Technical Bulletin

TB 0268 – Maximum height of pole mounted operational equipment

Figure 1

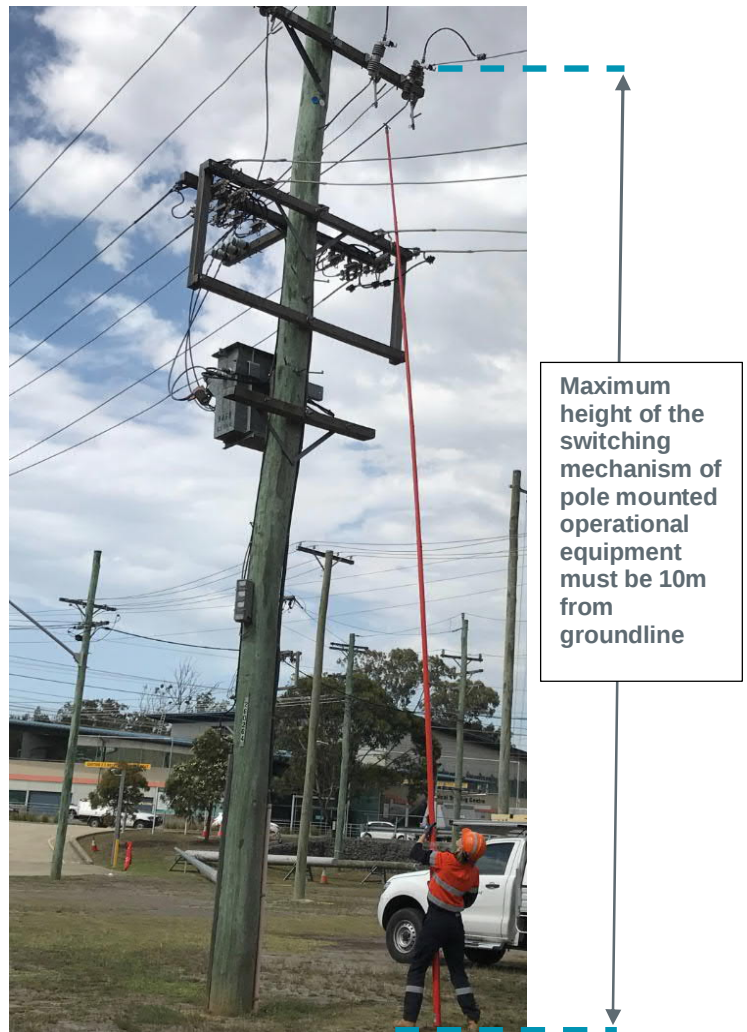
All new operational equipment such as USL, DOF, LBS and the like **must** be constructed such that their switching mechanism is no higher than 10m from the ground to allow their operation using an extendable link stick.

Where operational equipment is found with its switching mechanism higher than 10m from the ground, it is not a requirement to defect this equipment. However, if work is being completed on the pole, the operational equipment may be lowered, provided a design has been completed to ensure minimum clearances are maintained.
